M4 Junctions 3 to 12 Smart Motorway – TR010019
The Planning Inspectorate,
Temple Quay House,
Temple Quay, Bristol, BS1 6PN

Re: Project - M4 Junctions 3-12: Smart Motorway

PROPERTY LOCATION

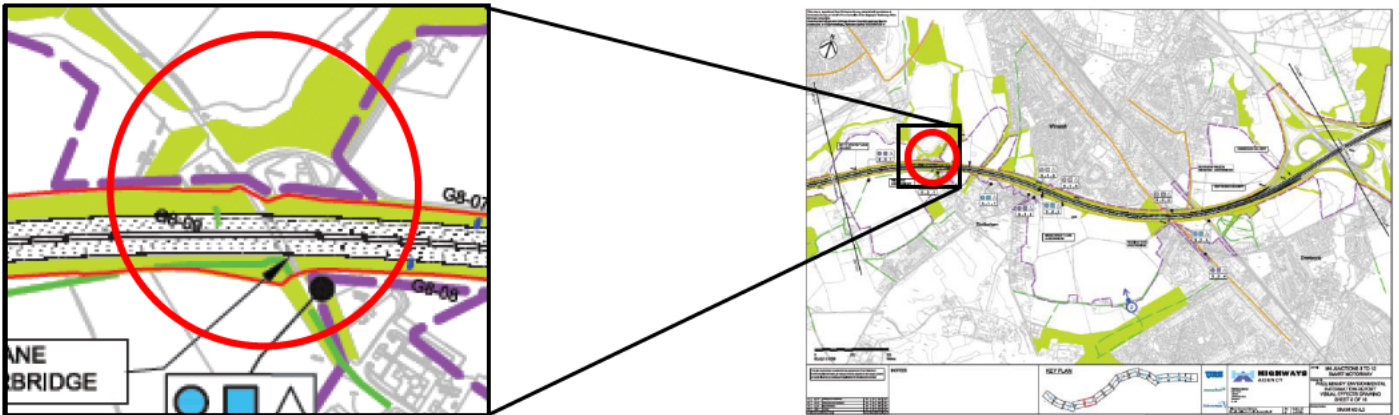
Our properties, Waterside & Hillside, are situated in Mill Lane, to the Northern side of the M4, on the west side of Mill Lane, between the Mill Lane Underbridge and the River Lodden Backwater. (Lat N 51°25'28.2, Lon W 000°53'39.5...Approximate - obtained using Phone GPS locator), the properties can be seen clearly marked on M4-PEIR_Drawing_09-2a_Habitats-J12-J89_Map-01-44.pdf, Map22 and on M4-PEIR_Drawing_04-1_Scheme-Plan_Sheet-01-19_J12-J10.pdf Sheet 16.

They are set at the base of the M4 embankment, with the motorway fence forming the boundary of Hillside (i.e. the house is within 15m of the hard shoulder barrier, so very close!).

In our opinion the ZVI (Zone of Visual Influence) line, indicated on M4-PEIR_Drawing_08-2_Visual-Effects_Key_Sheet-01-16.pdf Sheet 5, has been incorrectly drawn in the vicinity of our properties. The drawing shows the line coming back in line with the motorway boundary as it passes our properties. Although there are some trees on the motorway embankment, which provide some limited cover, they are deciduous and therefore provide next to no cover when not in full leaf, (6 months of the year). Even taking into account their spread in the future the view of our properties from the motorway will still be significant.

We have an unobstructed view of the motorway from the rear (also including from the side of Hillside) of our properties/bedroom windows/back door/gardens and the current hard shoulder lies approximately 2m (in elevation) above our rear bedroom windows. This means that any traffic using the hard shoulder (including trucks and vans in current lane 1) can easily see into our rear bedrooms etc., this issue has been highlighted recently due to the current roadwork scheme, which has been using the hard shoulder as a running lane.
